PLANNING COMMISSION MEETING STAFF REPORT

DATE OF MEETING: January 17, 2018
NAME OF PROJECT: Midway Springs
NAME OF APPLICANT: Watts Enterprises
AGENDA ITEM: Master Plan of Midway Springs
LOCATION OF ITEM: 600 North 200 East
ZONING DESIGNATION: R-1-15

Subject: Midway Springs, Phase 1 Preliminary, and overall Master Plan Approval

WATTS ENTERPRISES
 MIDWAY SPRINGS
 PRELIMINARY
 PHASING PLAN

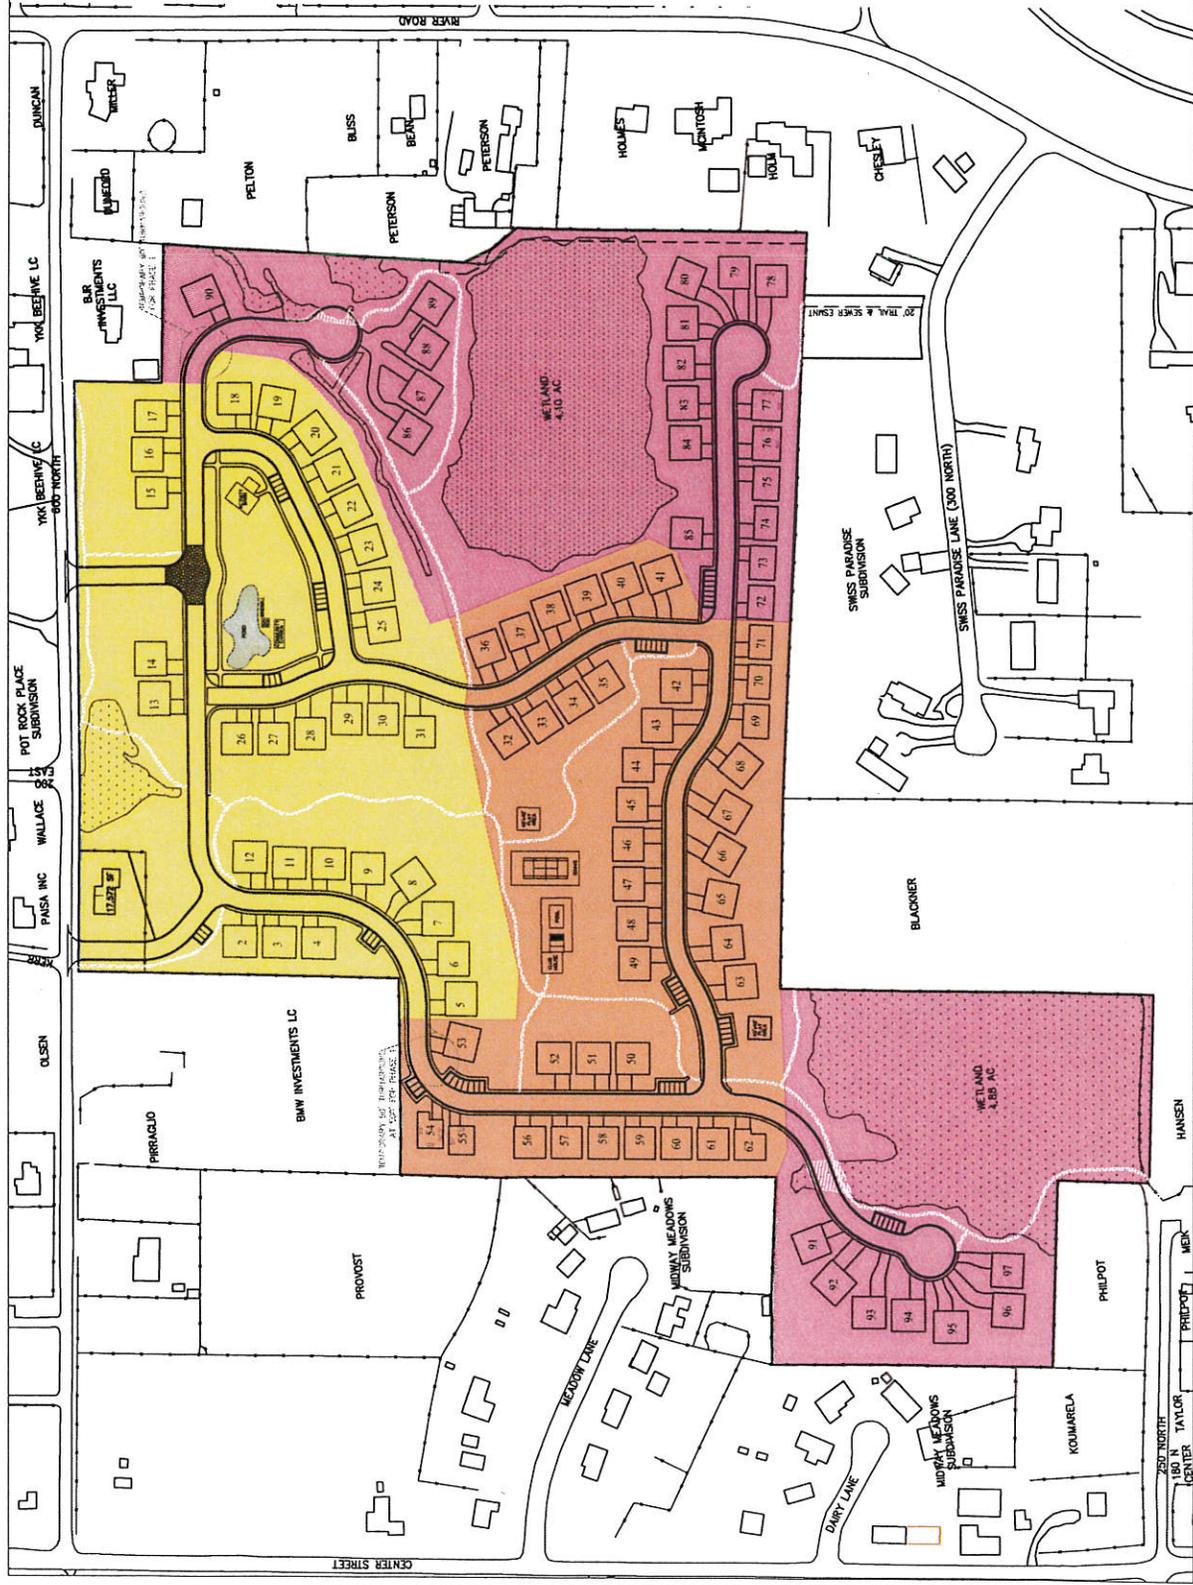
At this point it is unknown if the Midway Springs phasing plan does meet the requirements. More information is needed to assure that the open space acreage per phase has been met. Also, the development does need to receive a recommendation from the Water Board regarding the amount of water the development will need to tender to the City. Both items will be discussed later in this report.

Open Space – The code requires that with each phase that is approved there is enough open space to comply with the requirements of the code. For example, phase I must have at least 50% open space for that particular phase. If phase I has 75% open space, then phase II only needs to have 25% open space if both phases are equal in acreage. The development application does not include an acreage total of open space per phase. It is unknown if each phase meets the minimum requirements as required by the code. The overall total of required open space does comply with the requirements of the code.

1. Receive a recommendation from the Water Board before the proposal receives a recommendation from the Planning Commission.
2. Provide open space calculations per phase.

WATTS ENTERPRISES
 MIDWAY SPRINGS
 PRELIMINARY
 STREET & TRAIL PLAN

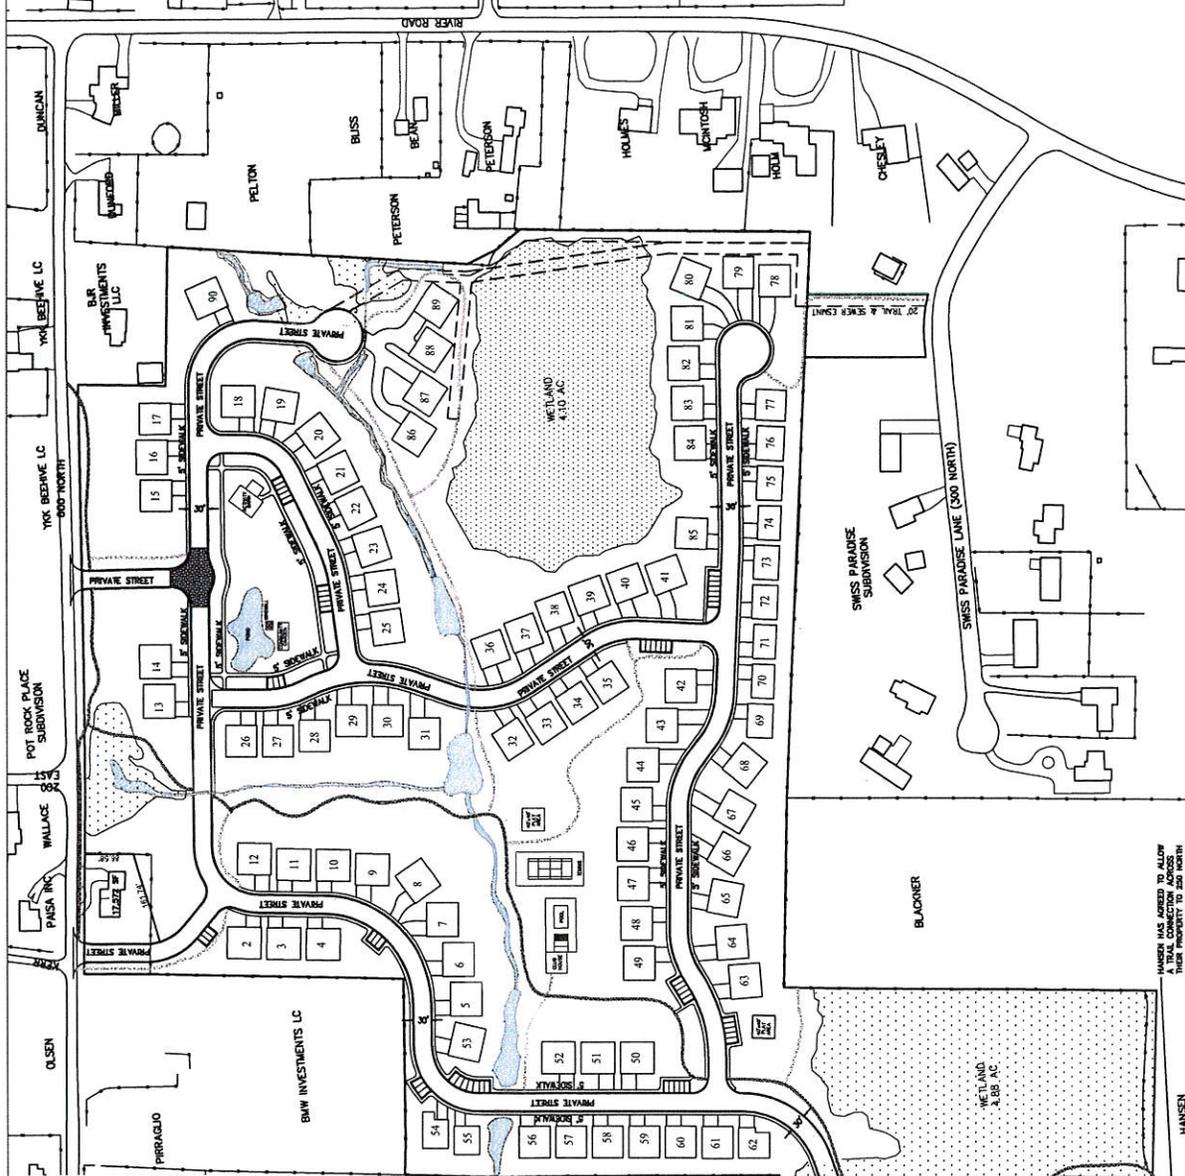
Trails – The Trails Master Plan and the Master Parks Plan calls for a linear park and trail to run north and south across the proposal. The City feels this is a very important community amenity that will benefit current residents and future residents for generations. Staff feels the trail should be of highest priority and careful review of the alignment and landscaping must happen to assure the trail will function and have the effect that it is envisioned to have. Staff also feels the trail should be built with the first phase in its entirety. If it is built per phase then it could take several years, if not more, to complete the trail. For this reason, it should be completed as a requirement of phase 1. The trail will be an 8' wide paved public trail that will be constructed by the developer. The trail plan also calls for a connection the Blackner property that is

- The proposed subdivision is showing several public and private trails within the development.
